ADDENDUM NO. 3

Perry Township Schools:
Southport High School Addition & Renovation Phase 1 (Activity Center Addition &
Wrestling/Center Plant Renovation)
971 E. Banta Road
Indianapolis, IN 46227

ADDENDUM NO. THREE

DATE OF ADDENDUM: February 12, 2026

UNIT R ROOF FRAMING PLAN
SCALE: 1/8" = 1'-0"

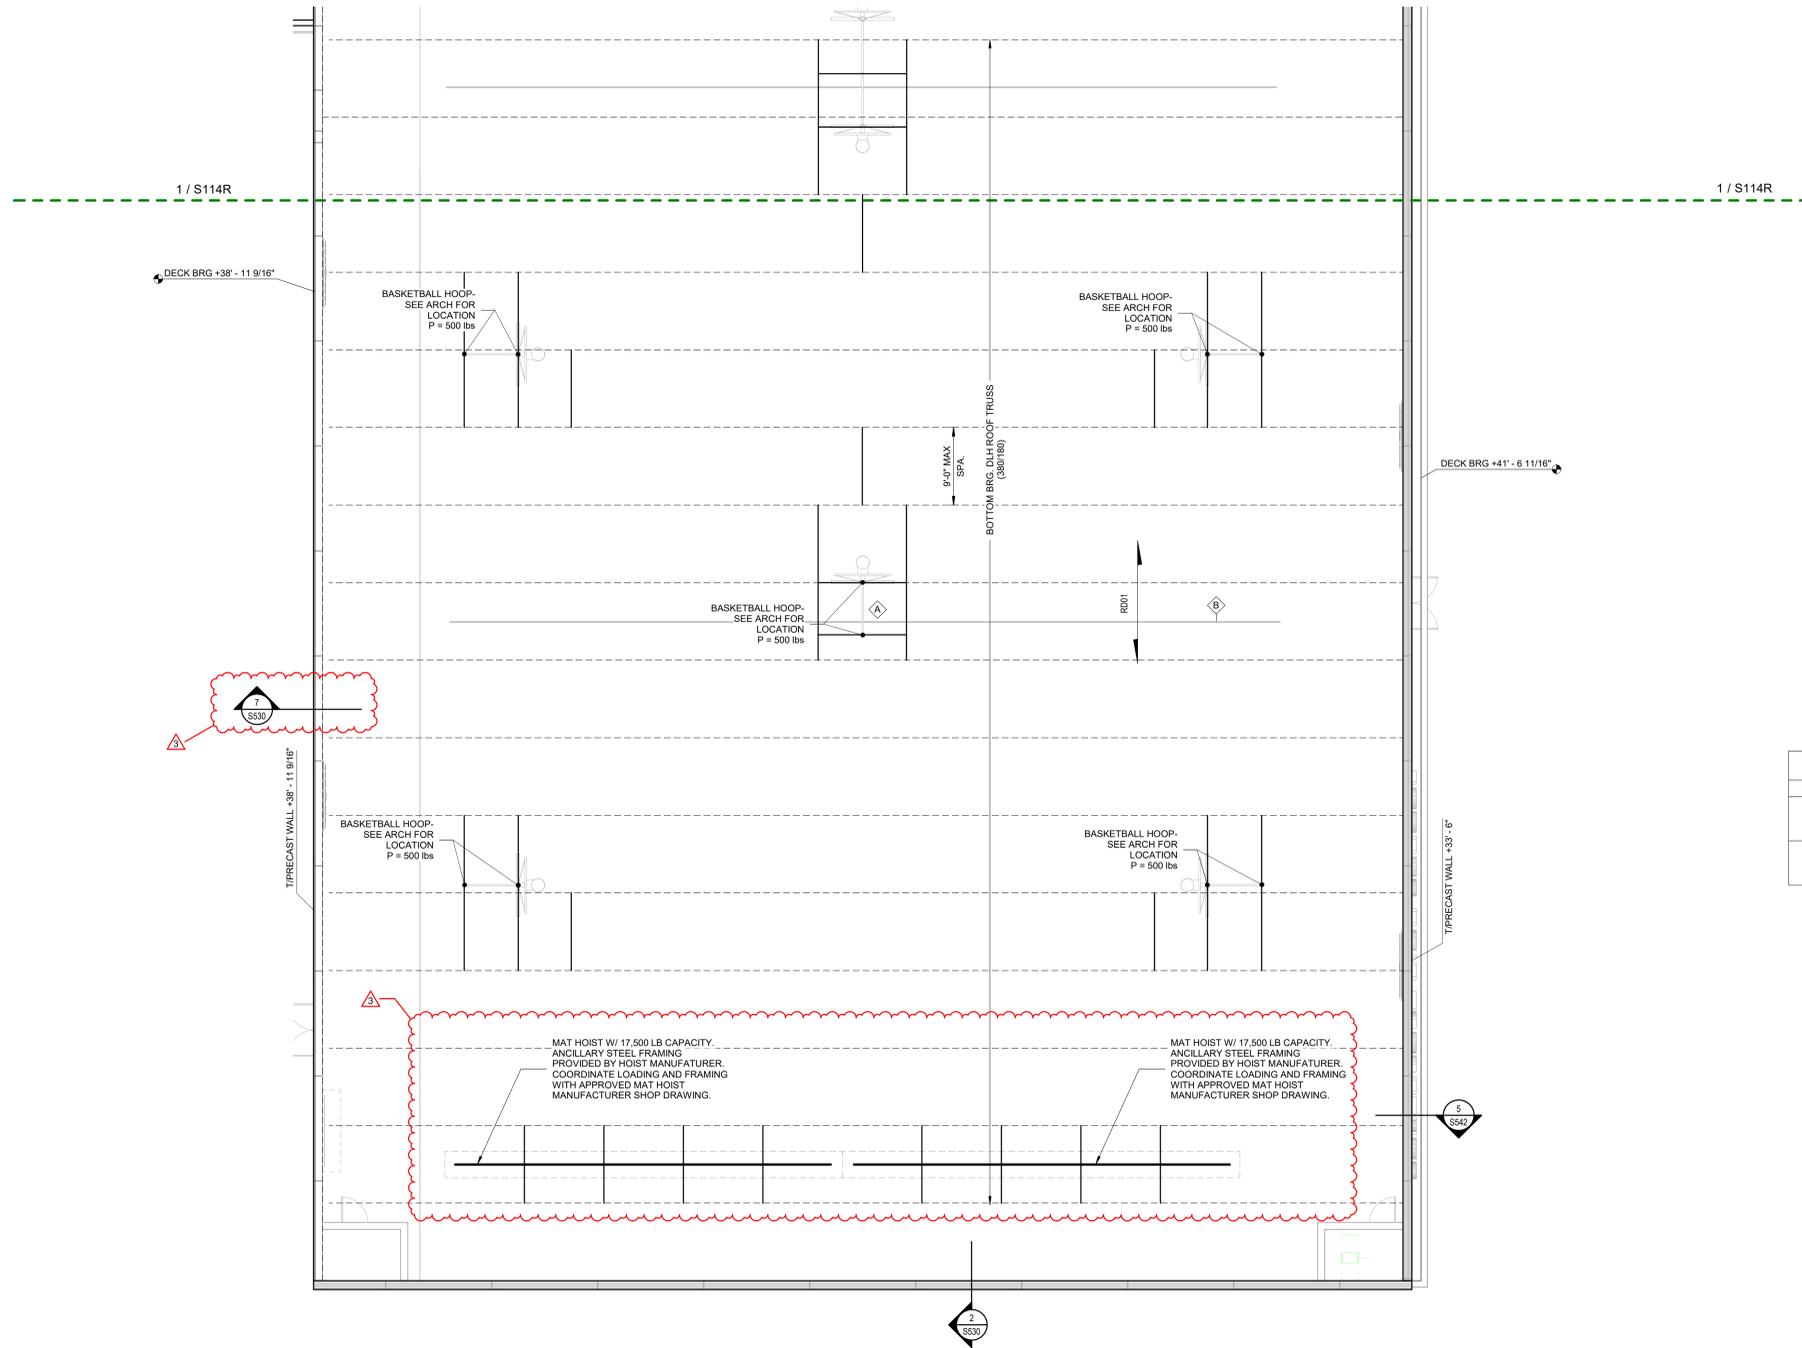
Change: Added Section.

UNIT S ROOF FRAMING PLAN

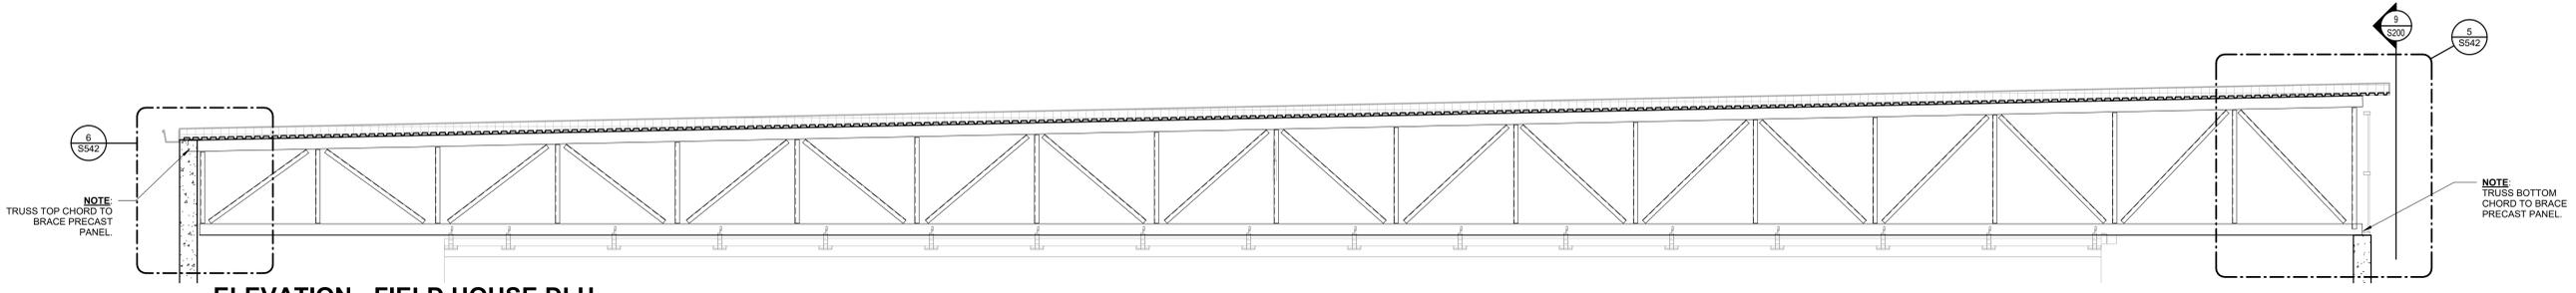
Change: Updated plan.

- Provided section 7/S530.
- Added hoist loading and location for roof trusses for hanging wrestling mats.

FRAMING ELEVATIONS

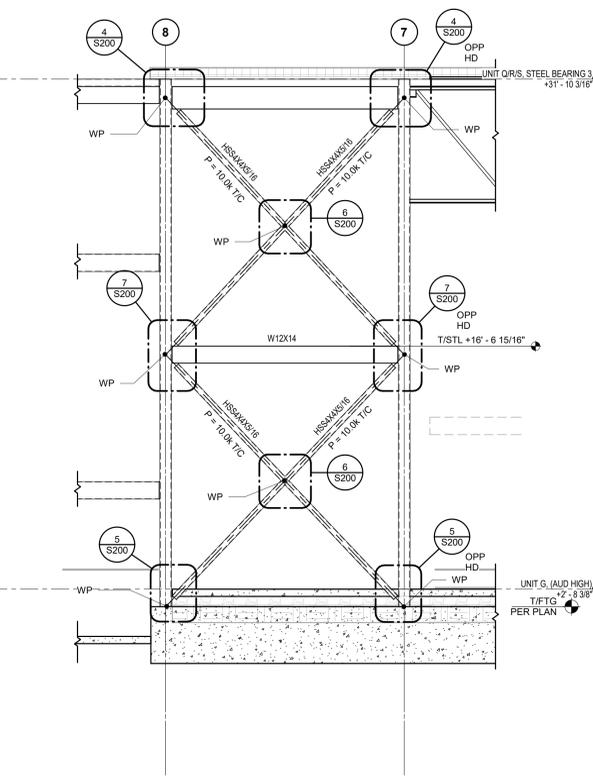
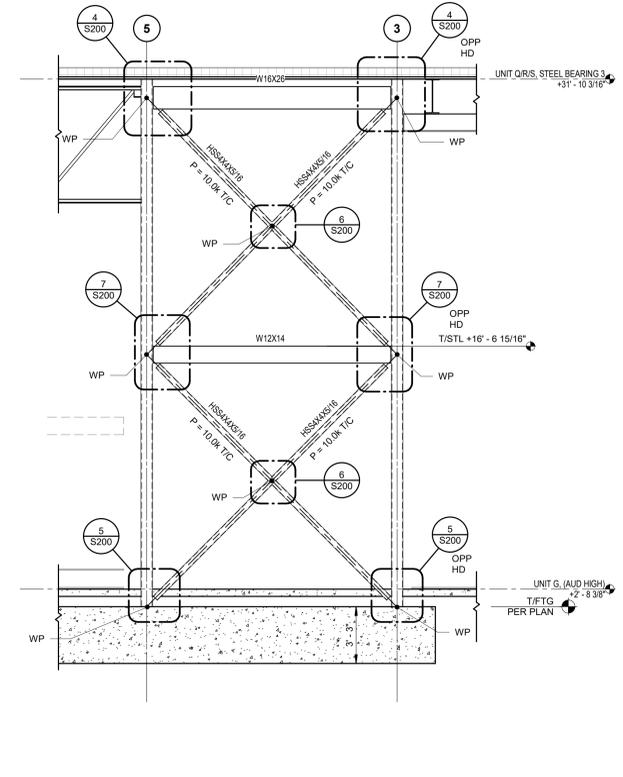
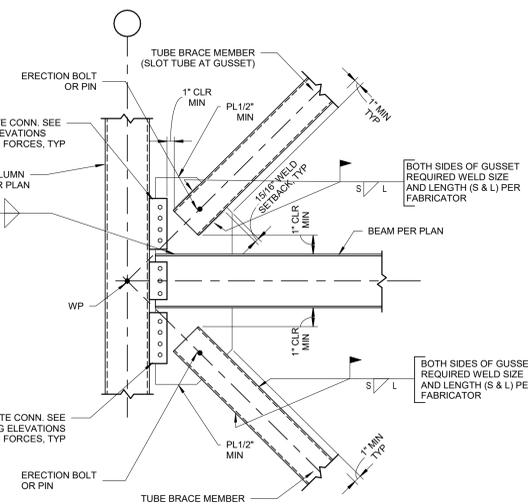
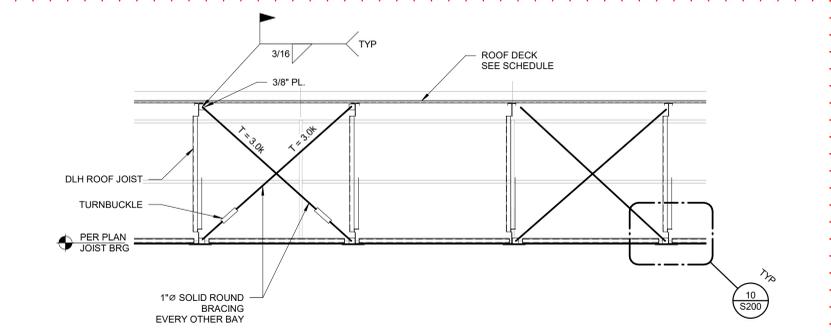
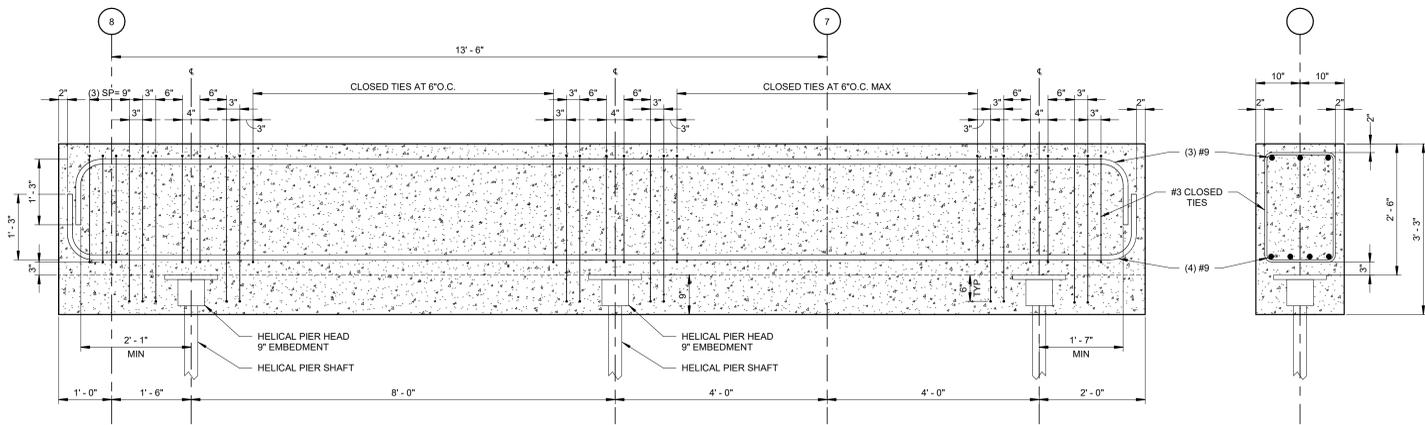
Change: Updated and added details.

- Updated detail 9/S200. Included HSS tube per precast manufacturer's comments.
- Provided enlarged detail 10/S200 for connection clarity.

PRECAST SCHEDULES, SECTIONS, & DETAILS

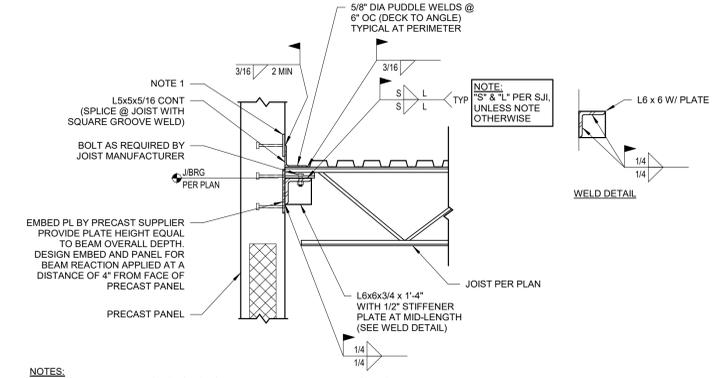
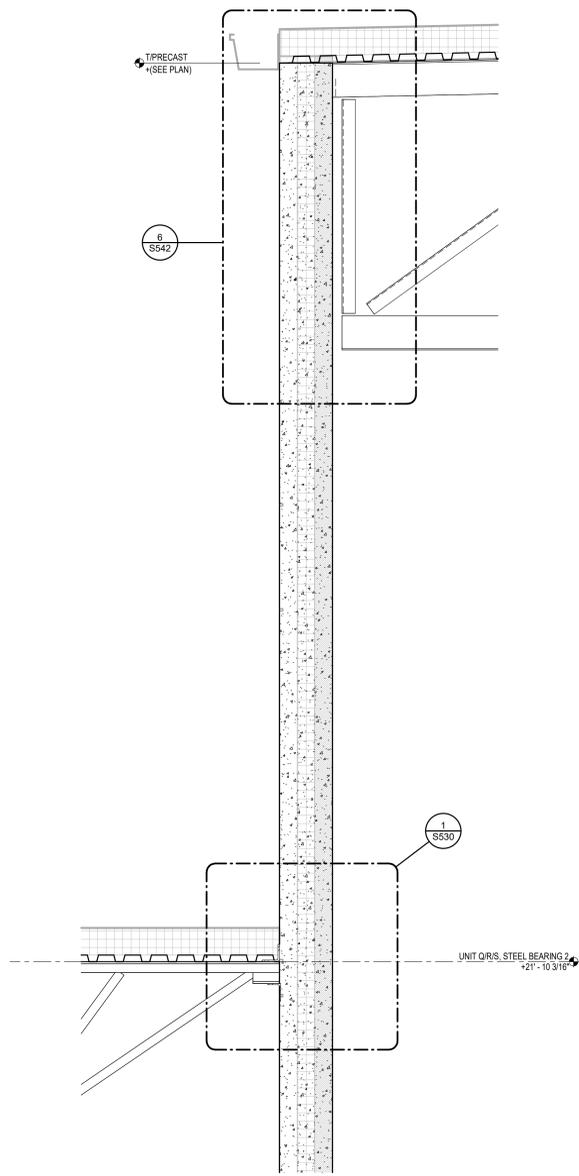
Change: Updated details, 2 & 4 and added detail 7/S530

- Updated detail 2/S530 and clarified detail title.
- Clarified detail 4/S530 detail title.
- Added detail 7/S530 to provide clarity of connection of deck between roof truss supports.

5 FIELD HOUSE TRUSS BEARING AT PARAPET
 SCALE: 3/4" = 1'-0"

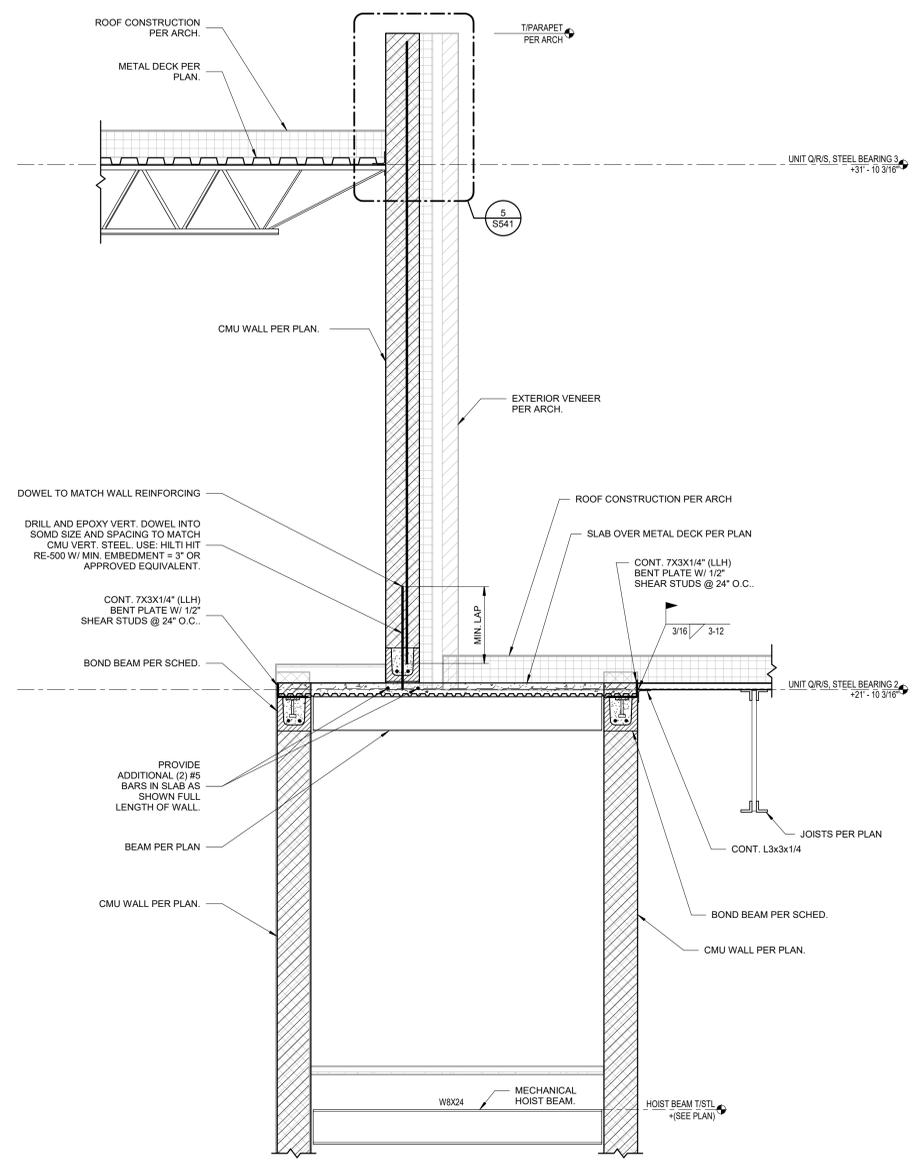
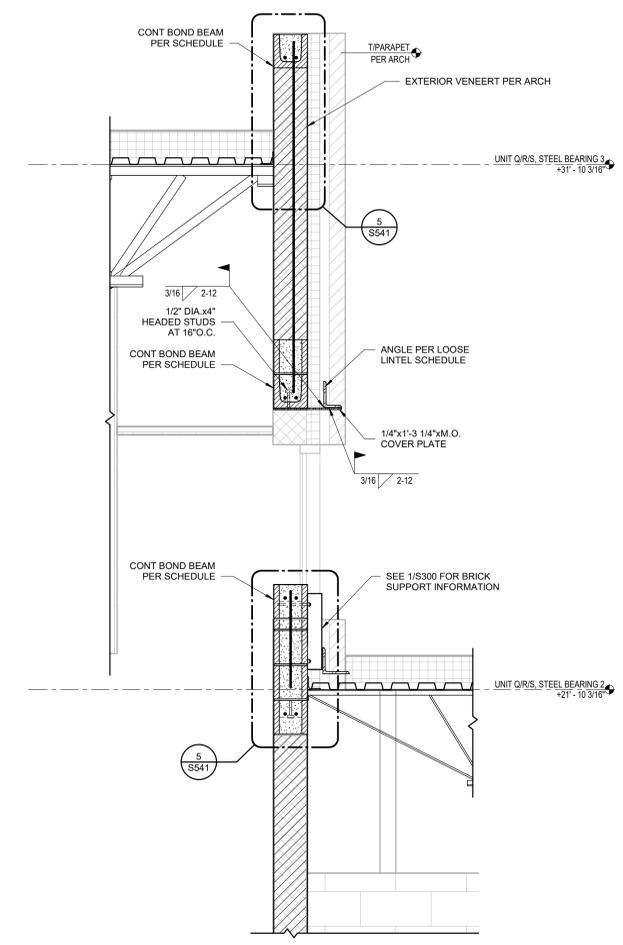
Change: Updated details, 5 & 6

- Updated detail 5/S542 for addition of HSS tube per precast manufacturer's comments. Updated/clarified roof truss bracing axial loads.
- Updated detail 6/S542 for deck enclosure size per precast manufacturer's comments. Updated/clarified roof truss bracing axial loads.
